Development Control – Delegated Officer Report

Application Number: AWDM/0511/17 **Recommendation – Refuse**

Site: **34 Middle Road Shoreham-By-Sea West Sussex BN43 6GA**

Proposal: **Proposed single-storey side and rear extension.**

Unacceptable infill extension

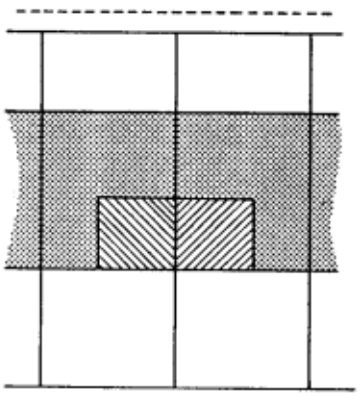
3.3 Where dwellings have been built with projecting sections it would not usually be acceptable to build an extension infilling the space between the projection and the boundary with an attached dwelling, unless both property owners co-operate to build a combined extension. This is because the property which was not extended would be left with rooms in a deep recess which would have a poor outlook and insufficient light.

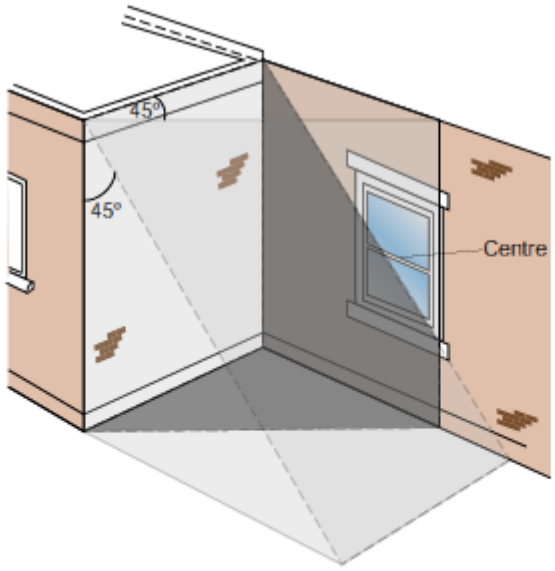
Its depth, height and width and proximity mean that the neighbour at No 32 would suffer serious and unacceptable harm to outlook and natural light from the east facing ground floor window in its outrigger and south facing window in the main part of the dwelling and inner courtyard- the tunnel effect. The said windows both serve habitable rooms and the south facing window is the only window serving this room. The courtyard will be enclosed by tall buildings on three sides- the extension being significantly taller than the existing boundary fence- and, despite being south facing, will suffer significant and oppressive overshadowing outside of midday. The principles of the BRE will be clearly breached in that the extension breaks the 25 degree rule for the east facing window in N0 32's outrigger and 45 degree rule for the south facing window. No study to demonstrate that natural light impacts would not be harmfully affected has been submitted. These rooms will become unacceptably gloomy- see below for relevant sections
